Intel[®] Ethernet Controller I210

Specification Update

Revision 2.9
332763-013

Figure 1-1. Explanation of Top Markings for A3 Stepping

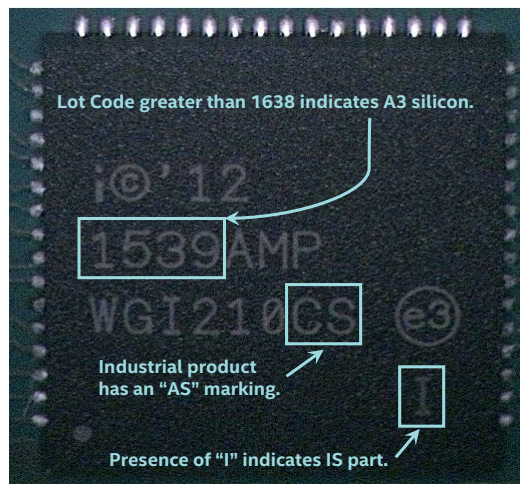
The A3 stepping only applies to the Fiber (IS/CS/CL) products. The A3 stepping can be identified by the Fab Lot Trace Code marking on the package or by the iNVM contents.

- Fab Lot Trace Codes starting with 1638 or greater are A3 devices.
- Bit 1 of INVM_DATA[61] (0x12214) is 1b on A3 devices.
